Board of Supervisors

Appeal of Planning Commission's Decision to Uphold Design Review Committee Approval for West County Transportation Agency's Phase II

3300 Juniper Avenue

DRH22-0008

Phase II Site Plan/Landscape Plan

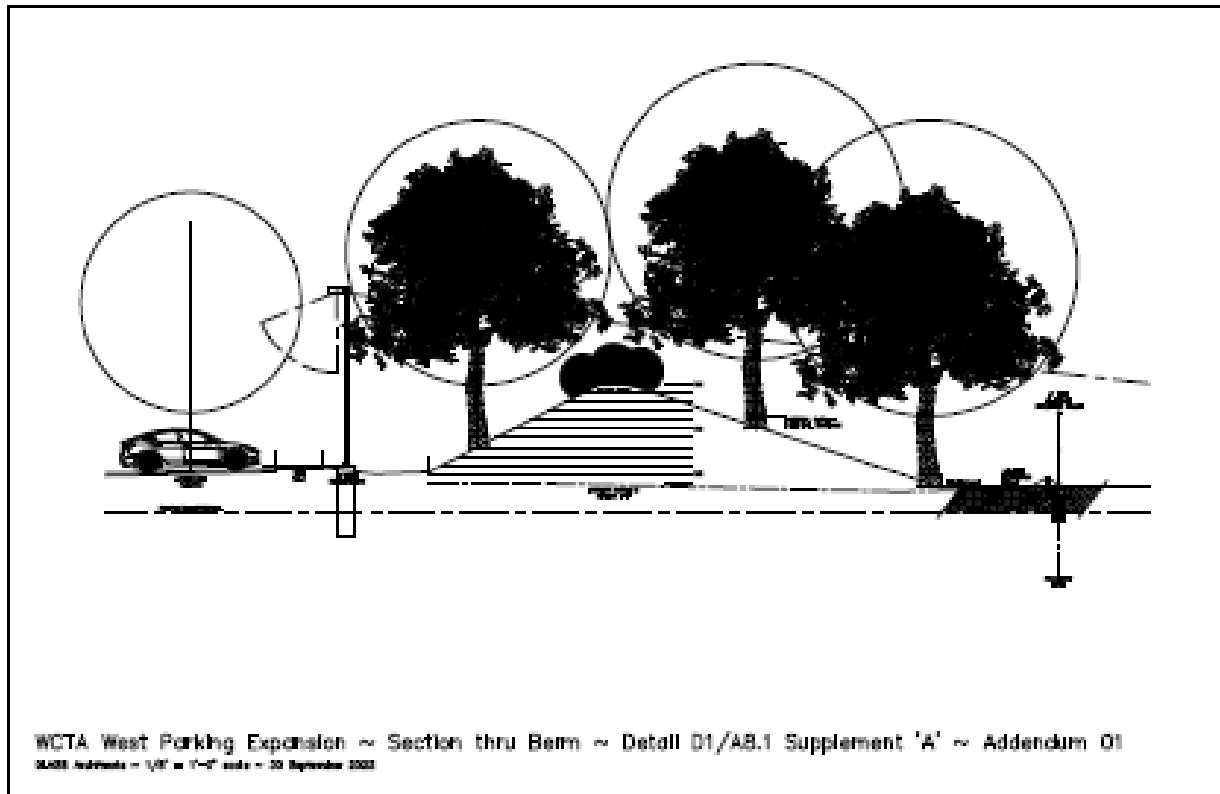
- Determined that Phase II was consistent with 1999 COA, including 80 bus parking spaces and 80 bus driver parking spaces.
- DRC Approval:
 - Plant additional trees along north berm and at northeast corner of site;
 - Include shrub planting along the berm at northeast corner;
 - Open wire security fencing ok on property line.
 - Lower light fixtures in employee parking area from 27 feet to 14 feet.
 - Lower light fixtures in bus parking area from 30-35 feet to 16 feet.
 - Lower color temperature of lights from 3000 to 2700 degrees Kelvin.
 - Auto dimming on all lights and power shut off on employee parking side.

Berm with proposed landscaping and lighting

Existing Berm to be landscaped

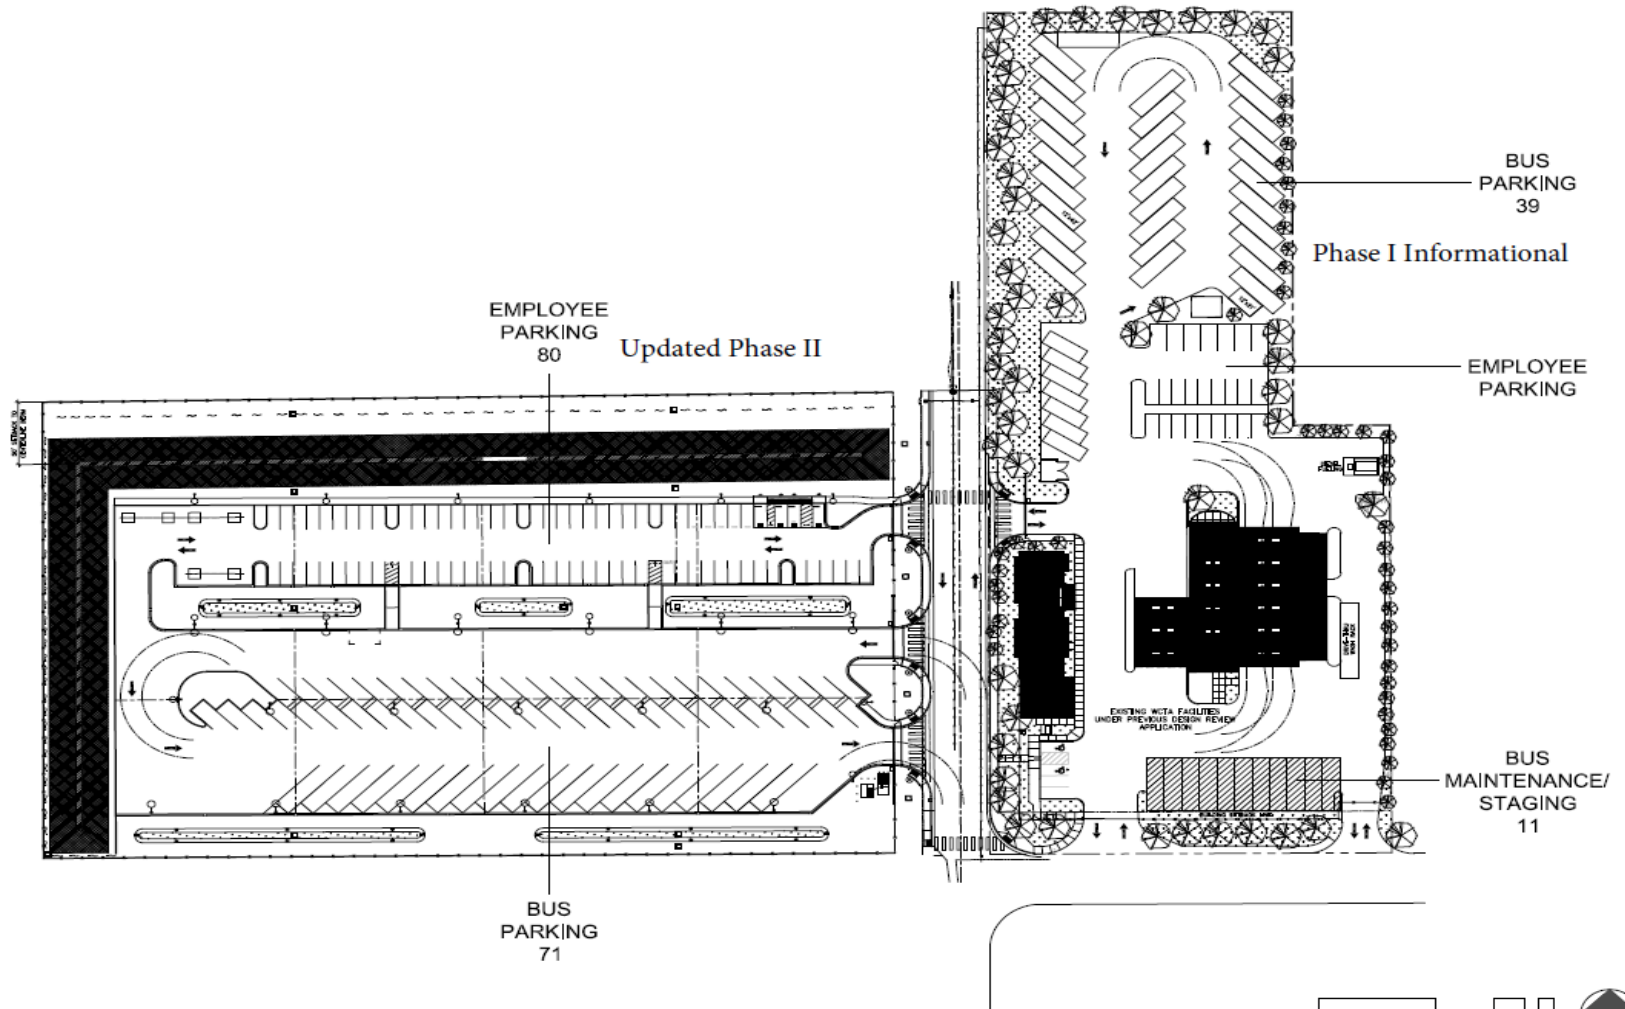
- Site Plan: Provide updated site plan for Phase II showing how the limit for 80 vehicles and 110 buses total would be met.

- Fencing: Directed staff to modify COA requiring fencing be relocated on the inside of the berm. No slats. COA 37.

- Lighting: Provide an updated lighting plan addressing shutting lighting for bus driver parking off between 6 p.m. and 6 a.m.
 - Determined that limited motion activated security lights at lower heights in bus driver parking area could be considered.

Applicants Response to 12/1 PC direction

- Applicant Response:
 - a. Updated Phase II site plan reduced bus parking on Phase II from 80 to 71 spaces
 - b. Confirmed site lighting in bus driver parking area would be shut off from 6 pm to 6 am.
 - c. Provided additional documentation on fencing, lighting and drainage

Updated Approved Phase II Site Plan

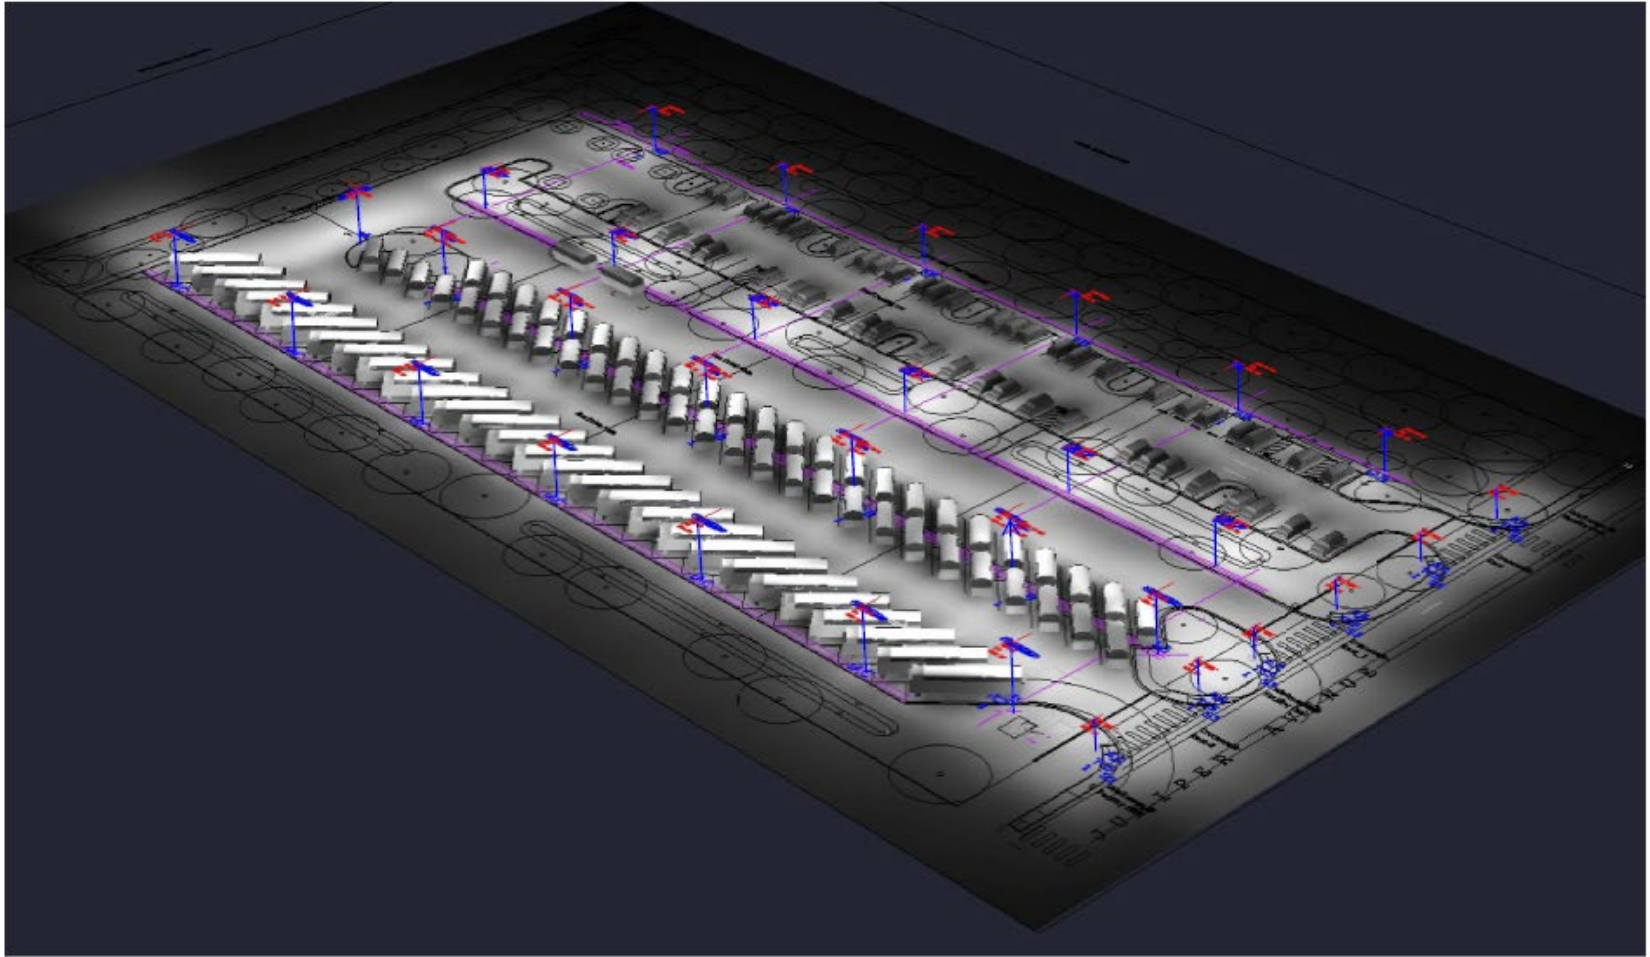
- Wire fencing at property lines, except Juniper Avenue/no slats except on south property line. Remove crossbar if feasible.
- Lighting approved in bus driver parking at 20' in height to be shut off from 6 p.m. to 6 a.m.
- Lighting approved in bus parking at 27' in height using motion activated fixtures. Lower lights if feasible.
- Lighting cut-offs and back shields required.

Wire Fence to North

Wire Fence and Drainage along North P/L

Bus Parking Lighting
